In the Matter of)
)
DUKE ENERGY FLORIDA, LLC) Docket Nos. 52-029 and 52-030
)
(Levy Nuclear Plant, Units 1 and 2))

NRC STAFF RESPONSES TO COMMISSION PRE-HEARING QUESTIONS

ATTACHMENT
Staff Responses to Commission
Pre-Hearing Questions

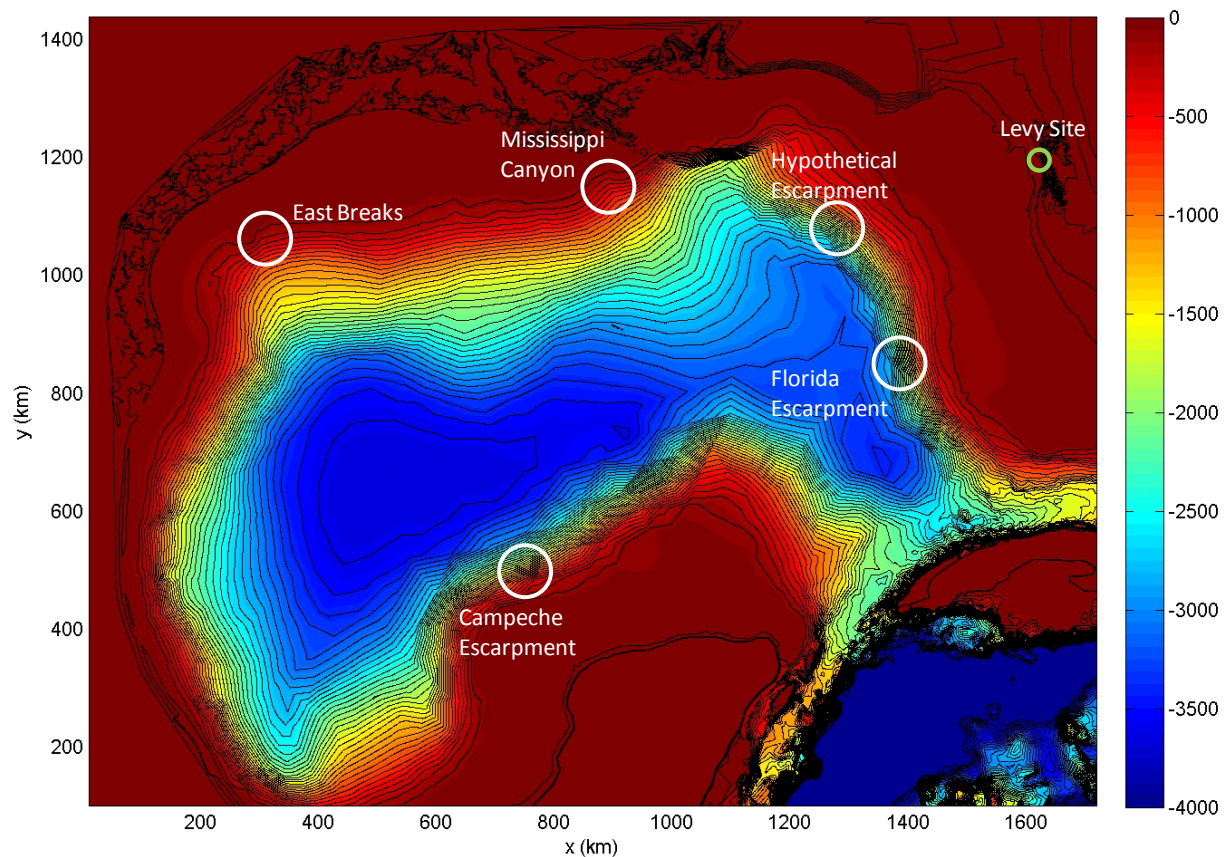
1. In its analysis of seismic seiches, the Safety Evaluation Report (SER) at 2-165 states: "Parameters for the maximum submarine landslide were determined for each of the provinces, except for the Campeche Escarpments where we are awaiting additional data."

New escarpment studies have recently been released (e.g., Monterey Bay Aquarium Research Institute, 2013) that map the escarpment in considerably more detail than studies that are reflected in SER Section 2.4. Did the Staff consider the more recent studies and their possible effect on the conclusions in the SER? If so what were the results?

Staff Response: The Staff did not consider the more recent studies referenced in the question. However, the Staff is confident that results from the 2013 multibeam mapping of the Campeche Escarpment have no effect on the conclusions in the SER. This is because the Staff used a very conservative independent tsunami hazard analysis to verify the applicant's probable maximum tsunami results. Since the data needed to develop a realistic estimate of the landslide parameters for the Campeche Escarpment were not available, the Staff developed very conservative estimates of the maximum-potential submarine landslide for the Campeche Escarpment. Specifically, the Staff performed one-dimensional numerical model simulations using a provisional tsunami landslide source located at the Campeche Escarpment to estimate the resulting potential for flooding at the Levy Nuclear Plant (LNP) site. Initial conditions for the landslide source were based on maximum observed landslide parameters along the Florida Escarpment, which is a similar geologic environment. The Staff's analysis for the Campeche source computed the wave runup to stop after progressing 0.6 miles inland. Since the LNP site is 9.6 miles inland, the maximum extent of the tsunami wave does not come within 9 miles of the site.

Similar one-dimensional numerical model simulations were performed for all the potential tsunami sources for the LNP site (See Figure 1). The model simulations employed by the Staff were conservative because they did not account for the radial spreading of the wave and did not account for friction. This approach resulted in conservative estimates of the size and runup of the wave. These model simulations confirmed the applicant's conclusion that the Mississippi Canyon source has the greatest potential to bring the large tsunami wave to the Levy site and was appropriately designated as the probable maximum tsunami source.

The Staff then conducted independent confirmatory two-dimensional model simulations for the Mississippi Canyon. The Staff's tsunami model simulations employed modeling assumptions that included additional conservativisms not included in the applicant's model, such as assuming that the entire submarine landslide volume 'slumps' instantaneously and into a large mass on the seafloor. The Staff's model produced results that showed the probable maximum

tsunami estimated by the Staff (20 ft) or the applicant (12.94 ft) would not reach the LNP site (site grade of 51 ft).
